SUBMITTAL OF HANFORD FACILITY RESOURCE CONSERVATION AND RECOVERY ACT (RCRA) PERMIT MODIFICATION NOTIFICATION FORM 24590-PTF-PCN-ENV-07-005

Permit Modification Notification Form 24590-PTF-PCN-ENV-07-005 updates the PTF General Arrangement Plan at the 77' elevation found in Appendix 8.4 of the Reference and includes an updated room and equipment list for elevation 77'. A one-to-one correlation between permit versions and source drawings does not exist. Potential permit affecting changes between the current and previous revisions of the source drawings on the permit change notice form are • briefly described in a summary format.

Hanford Facility RCRA Permit Modification Notification Form 24590-PTF-PCN-ENV-07-005

Hanford Facility RCRA Permit, Part III, Operating Unit 10, Waste Treatment and Immobilization Plant Update Pretreatment Facility General Arrangement Plan at the 77' elevation in Appendix 8.4 of the Dangerous Waste Permit.

| Appendix | 8.4 | | |
|----------|---------------------------------|-------|---------------------------------|
| Replace: | 24590-PTF-P1-P01T-P0004, Rev. 0 | With: | 24590-PTF-P1-P01T-00004, Rev. 3 |

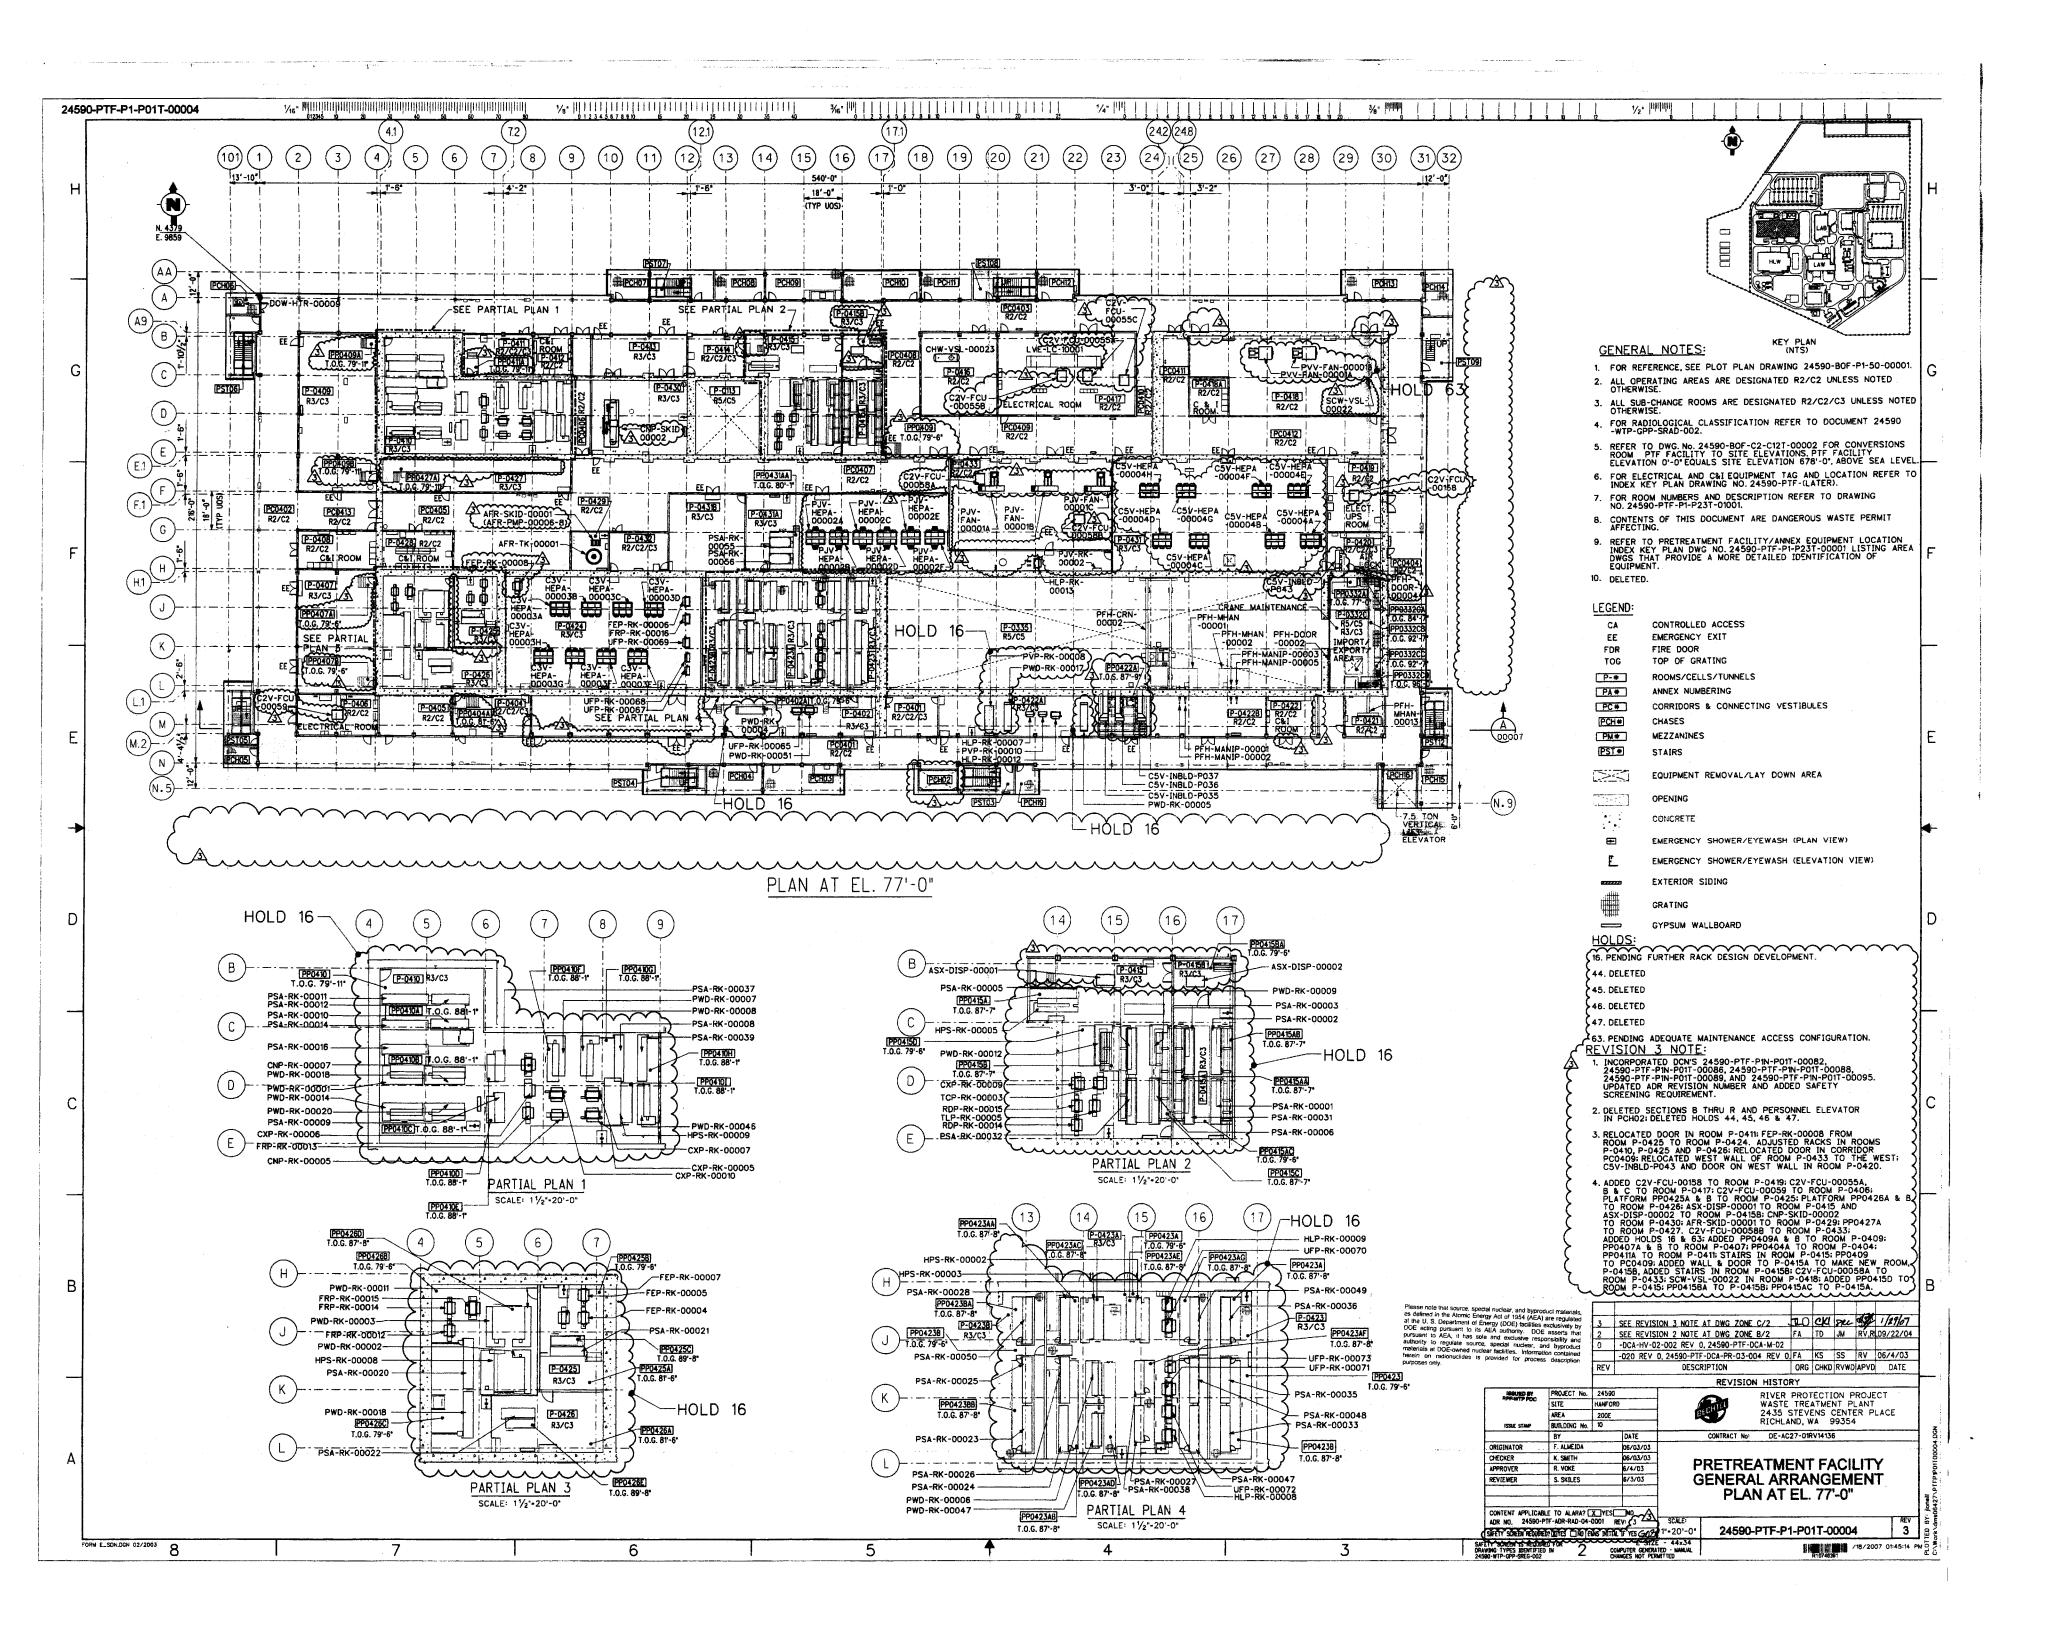
The purpose of this Class 1 prime modification is to update Pretreatment Facility General Arrangement Plan at the 77' elevation in Appendix 8.4 of the Dangerous Waste Permit. The following General Arrangement Drawing is submitted to replace the permitted General Arrangement Drawing currently in Appendix 8.4.

This modification requests Ecology approval and incorporation into the permit the specific changes to the General Arrangement Drawing that are identified by the Revision 2 and 3 notes, clouds, and revision triangles shown on the General Arrangement Drawings that have been issued since the last revision of the permitted version. Revisions are the result of ongoing design. The following is a summary of the significant changes on the attached drawing:

- Relocated equipment within and between rooms
- Added new rooms and adjusted the boundaries of rooms
- · Added, adjusted, and relocated racks
- Added and removed holds
- · Added component identification numbers for skids relative to equipment
- Various changes to the depiction of equipment/structure
- Identification of additional information as a result of going from permit drawing to the engineering design drawing
